The application has failed to accurately account for the position and layout of the adjoining properties.

Register Ref: SD22A/0390
Development: Demolition of an existing two storey detached dwelling (162sq.m) and associated out-buildings on site and the construction of 7 two storey (plus dormer level); 5 bedroom houses comprised of 3 detached houses and 4 semi-detached houses on a site area of c. 0.3ha; all associated site development works, car parking, open spaces and landscaping etc; proposed access to the development will be via the existing vehicular entrance on the Lucan-Newlands Road / Esker Hill.
Location: Clonbrone, Lucan Newlands Road, Esker Hill, Lucan, Co. Dublin, K78 Y5C2
Applicant: Nacul Developments Ltd
Application Type: Permission
Date Rec'd: 13-Oct-2022

Figure 2.0

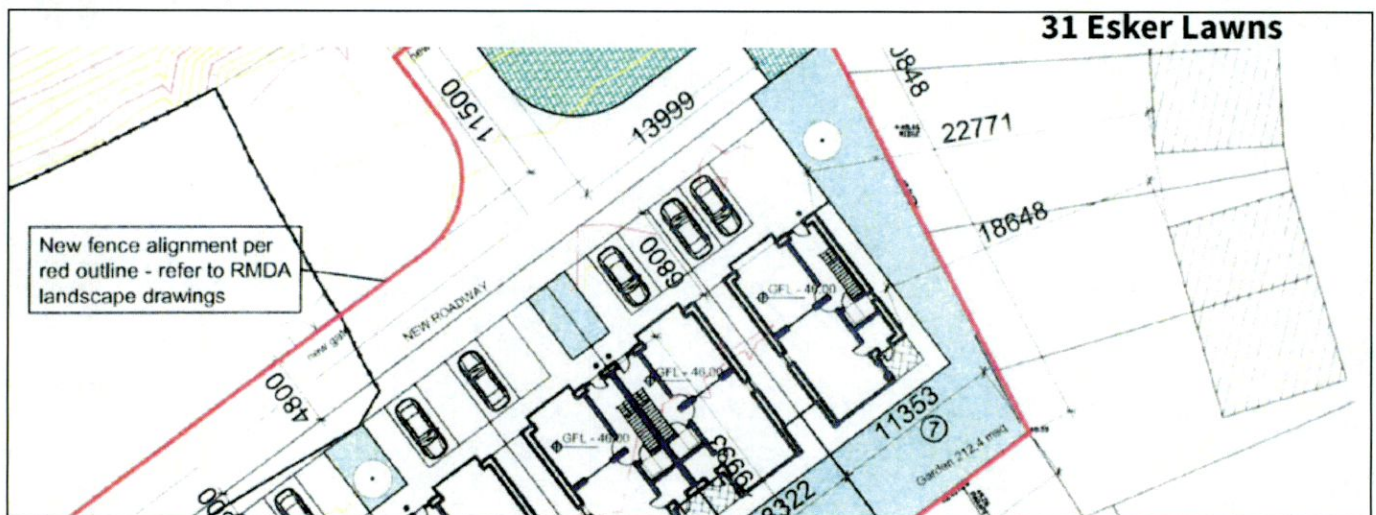
Figure 2.0 shows our property, No. 31 Esker Lawns as represented in the plans. However, Figure 2.1 illustrates our home, 31 Esker Lawns, to include a 65m² glass fronted ground floor extension which has been in place since 2016 (Planning history SD15B/0188) which is not shown on the plans for this proposed development.

The result is that proposed house no. 7 is significantly closer to our property than the plans suggest. House No 7 is 15.8 meters from our home, rather than the 22.77 meters claimed by the planning document (Figure 2.0). In order for there to be a true distance of 22 meters, House No. 7 would need to be located approximately 10 meters from the boundary wall; it's currently proposed at just 3 meters. See figure 2.1 below for details.

Figure 2.1

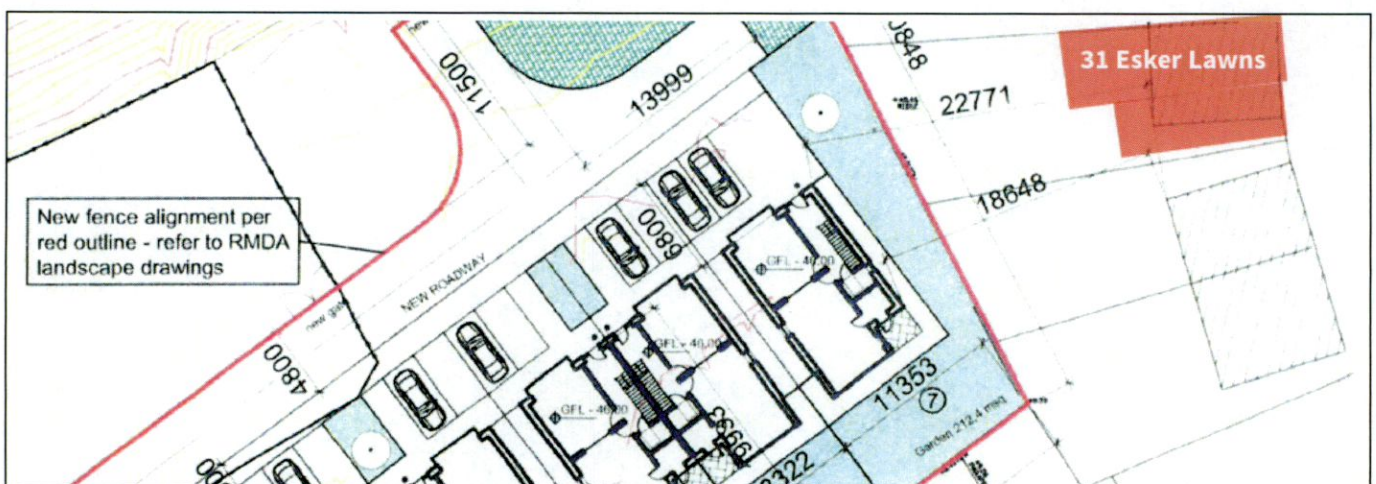
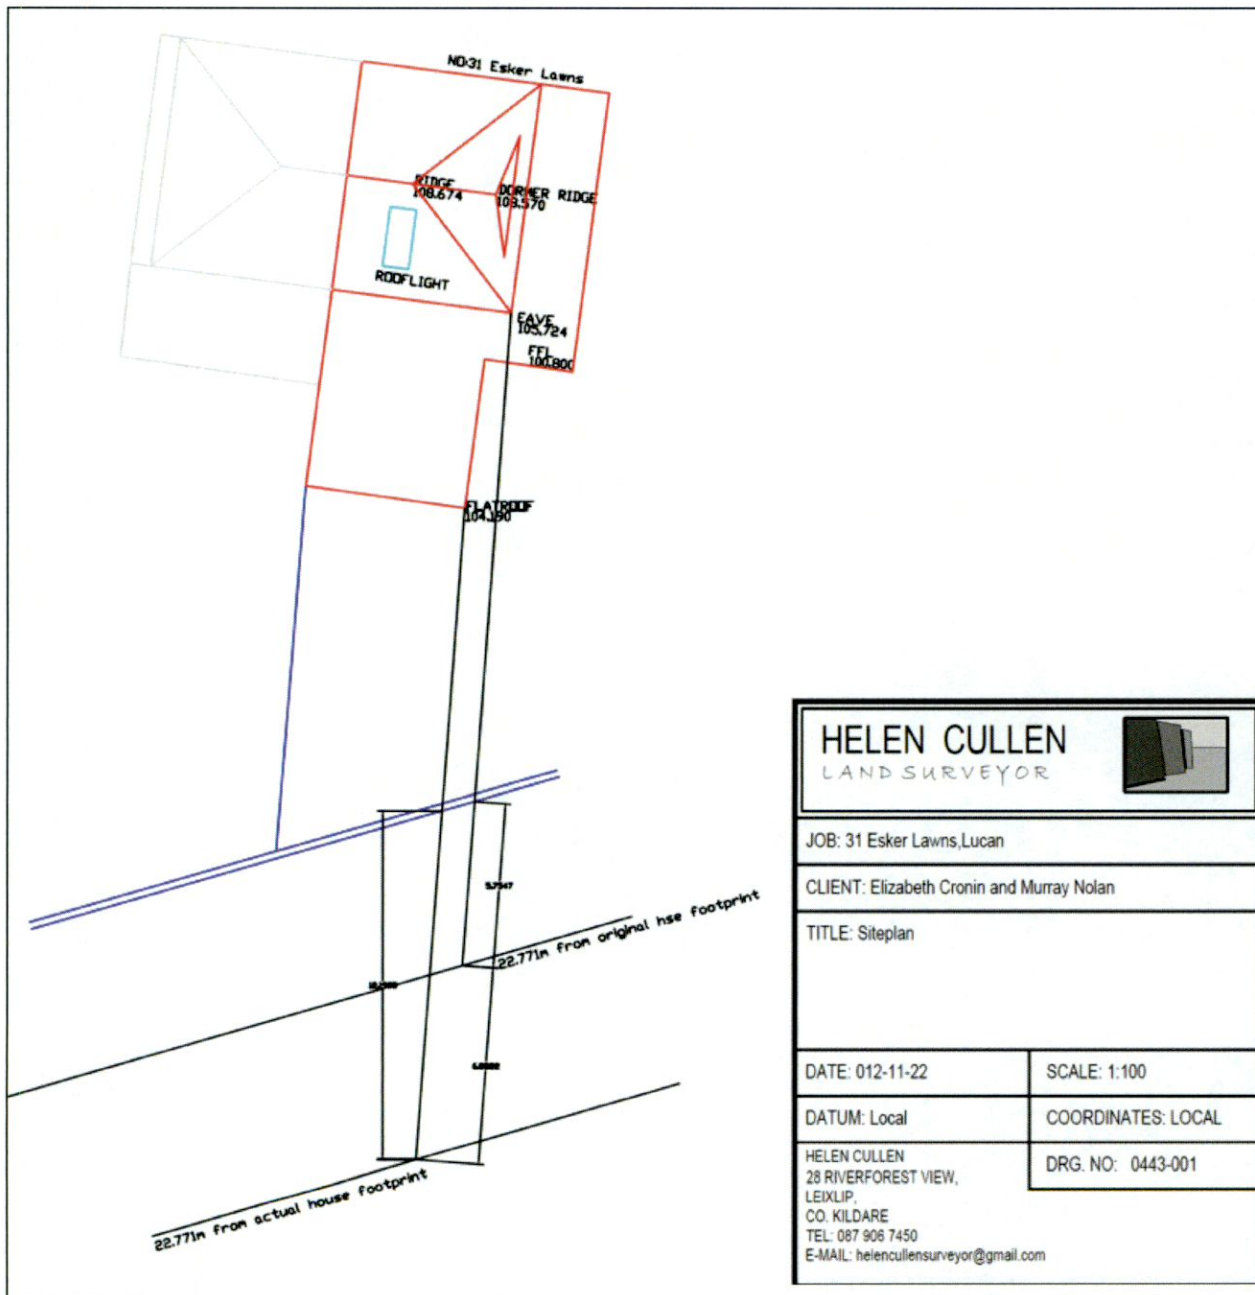
As a result, the footprint of our property is larger than illustrated in the planning documents, and is not reflected in the site layout.

Figure 3.0

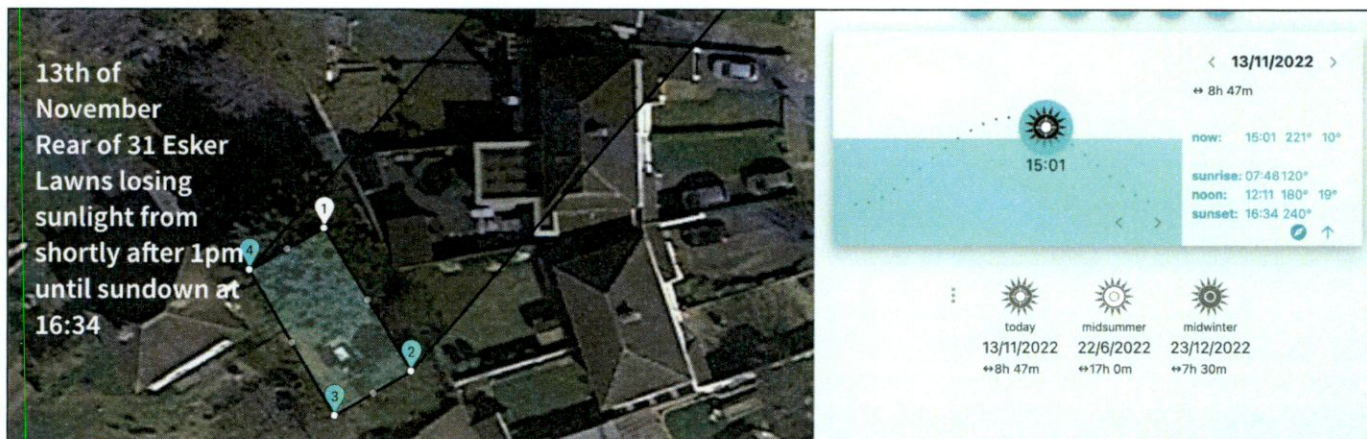
No 7, as proposed, casts a shadow on our extension and garden throughout much, if not all, of the afternoon during the course of the year, particularly from September through to the end of March. Thus our enjoyment of the amenity of our home and garden will be severely diminished. See Figure 3.0 and 3.1

Below we have provided examples of shadowing at different dates and times of year to illustrate the impact on the illumination of our home and garden. See Figures 3.0 and 3.1
